NUMBER: 25-003-01

Erroneous DTC P1398 (or \$BA) - No Crank Sensor Learn

This bulletin involves selectively erasing and reprogramming the Powertrain Control Module (PCM) with new software (calibration level 96Cal18 or 97Cal18).

Fig. 1 AUTHORIZED SOFTWARE UPDATE LABEL

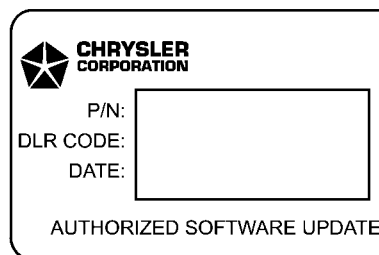
2. Type the necessary information on the "Authorized Software Update Label" p/n 04669020 (Fig. 1). Attach the label to the Powertrain Control Module and cover the label with the clear plastic overlay.
